RELEASE NOTES

Product: QRAE 3

Version: V2.16A
Release Date: September 2019

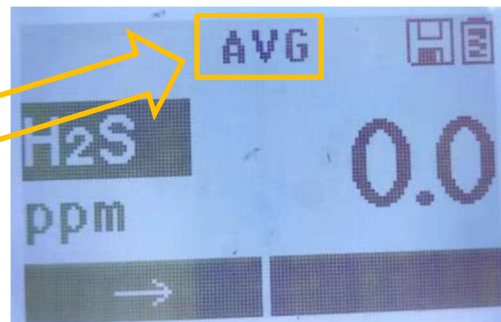
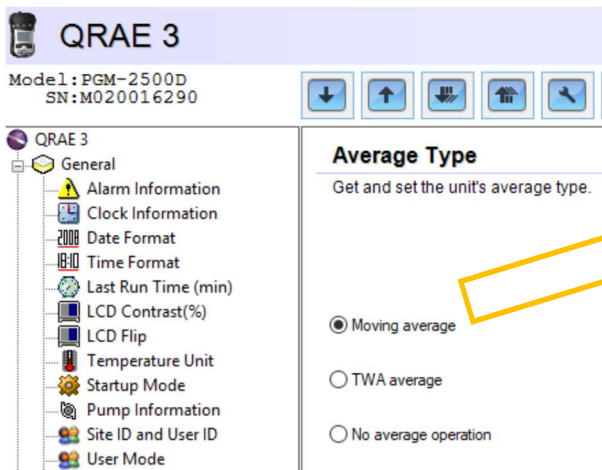
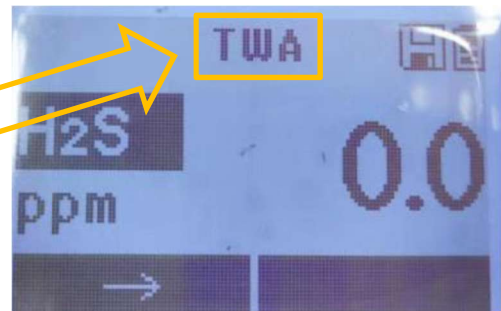
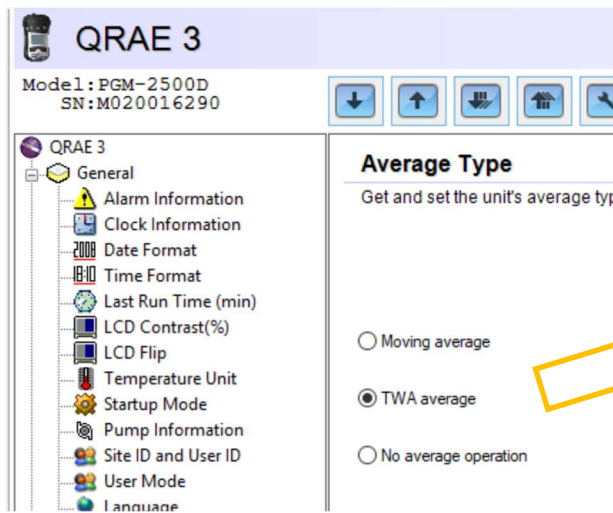
ID	Description
QRAE3-47	Sensor Serial Number cannot be written successfully during the first time on ProRAE Studio II. It shows "SO*****".
QRAE3-42	Fix previous User interface issue (See details below).
